Cowlitz Indian Tribe

June 13, 2016

**RE: Comments Regarding the Draft Environmental Impact Statement (Draft EIS)
Concerning the Proposed Millennium Bulk Terminals-Longview.**

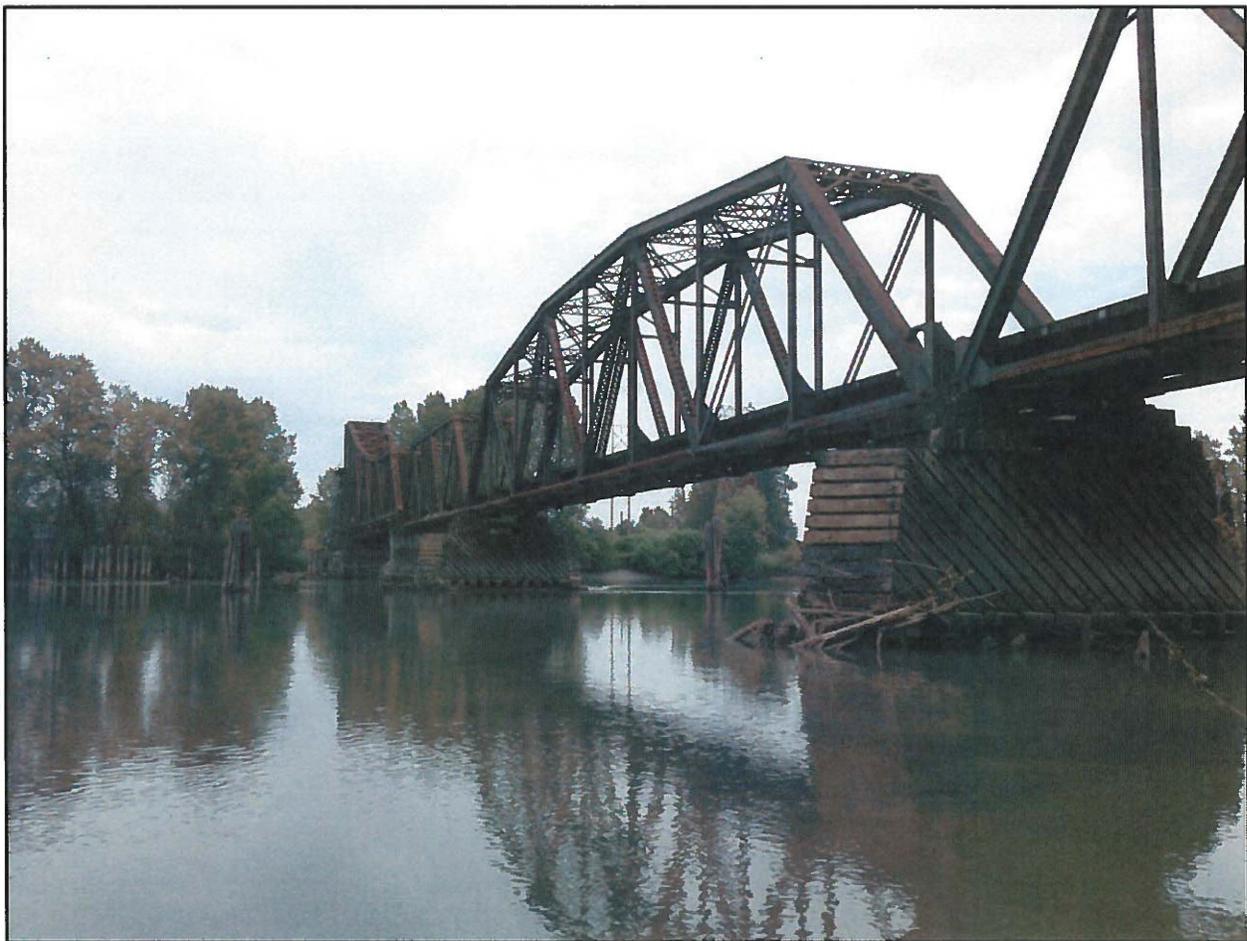
In no chapter, section, or appendices in this Draft EIS are we able find any information as to the current existing condition of the BNSF – Cowlitz River Bridge. It does speak of potential threats in relation to the future potential issues with the bridge and it does mention a “possibility” of improvements to the bridge, but it doesn't mention why?

- **In light of all the National concerns as it relates to rail safety, why is there what seems to be oversight and lack of detailed information regarding the BNSF - Cowlitz River Bridge condition in the Draft EIS?**

- **Why is there a current 10 mph speed limit across the bridge?**

Upon our own investigation, here is some insight as to its condition which deservedly should have additional engineer details as to its current state and future potential threats. The following picture was taken by our Natural Resources Department on 06/08/2016:

- It looks as though this bridge is old, rusty, with wood railroad ties surrounding the old concrete footings.

- Do you mean to tell us that there are plans to continue utilizing an old 1908 bridge that wasn't even designed for the Cowlitz River for current and future industrial rail traffic?

- **We request that more analysis and information regarding the BNSF Cowlitz River Bridge and that the Action agencies update the Draft EIS and re-issue another Draft EIS for another comment period before a Final EIS is issued.**
- **We request that the current use, proposed Action and this SEPA process should cease until all issues, concerns, processes, and potential solutions to the BNSF - Cowlitz River Bridge are resolved.**
- **With current conditions of the BNSF - Cowlitz River Bridge and if railroad users obey the rules attached to the bridge; if there is an accident due bridge failure; who would be the responsible party?**
- **What would be the potential impact if a derailment would occur at the Cowlitz River Bridge?**
